## Access Compliance Report Public Rights-of-Way (Curb Ramps)

Intersection ID: 49926Main Street:CAMPBELL\_HALL\_CTCross Street:WOBURN\_RDLocation:NEADA ID: 19417B1B340ERamp Type:PerpInitial Pass/Fail:PassOverall Compliance:NoSeverity Score:22.5

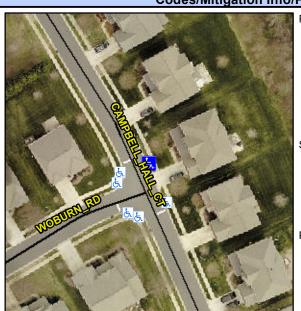
Not Found, R304.2.1, R304.2.3,
R305.2, R302.7.2, R304.5.4

Field Measurements/Component Compliance							
Compliance Description		Data	Compliance Description		Data		
N/A	Ramp Length (in)	47.0	Yes	Ramp Slope (%)	5.7		
Yes	Ramp Width (in)	48.0	Yes	Ramp XSlope (%)	0.3		
N/A	Flare Type LT	Sloped	N/A	Flare Type RT	N/A		
N/A	Flare Slope LT (%)	10.9	No	Flare Slope RT (%)	10.7		
N/A	Flare Traversable LT?	Yes	N/A	Flare Traversable RT?	Yes		
No	Landing Length (in)	47.0	Yes	DWS Provided?	Yes		
Yes	Landing Width (in)	48.0	Yes	DWS Contrast?	Yes		
Yes	Landing Slope (%)	1.9	Yes	DWS Length (in)	24.5		
Yes	Landing X Slope (%)	0.5	Yes	DWS Full Width?	Yes		
N/A	Landing Curb? (Y/N)	No	No	DWS Offset (in)	3.5		
N/A	Shared Landing?	No					
Yes	Gutter Ponding?	No	No	Gutter Slope (%)	6.3		
No	Gutter Lip Ht (in)	1.0	Yes	Gutter X Slope (%)	0.3		
N/A	Painted X Walk1?	No	N/A	Painted X Walk2?	N/A		
	X Walk 1 Direction	To SW		X Walk 2 Direction	N/A		
N/A	X Walk 1 Width (in)	N/A	N/A	X Walk 2 Width (in)	N/A

Remove & Replace Entire Ramp.
Remove & Replace Gutter.
